**Peace River Town Hall – Accessibility
Upgrades
Peace River, Alberta**

ADDENDUM NO. TWO

ELECTRICAL ADDENDUM E01

REASON FOR ADDENDUM: Lift system electrical requirements co-ordination.

1. Drawing E04

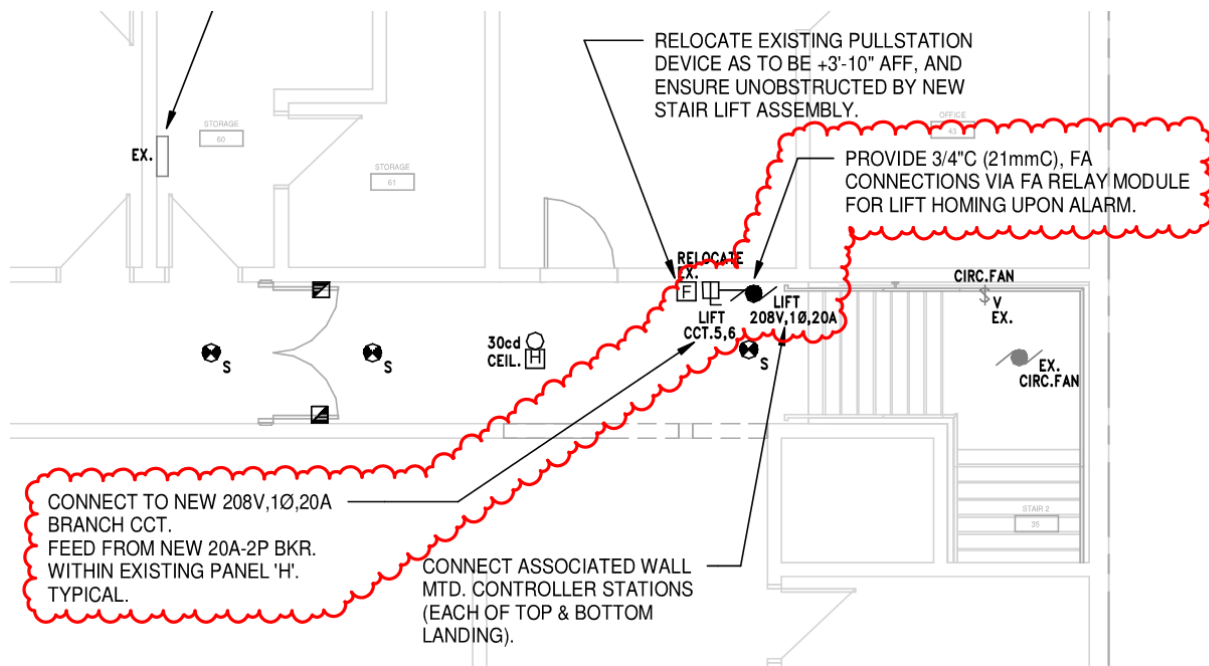
REV: 4th Floor Stair 2 Area
Revise electrical connections for lift system to be as shown within the clouded region of the sketch below:
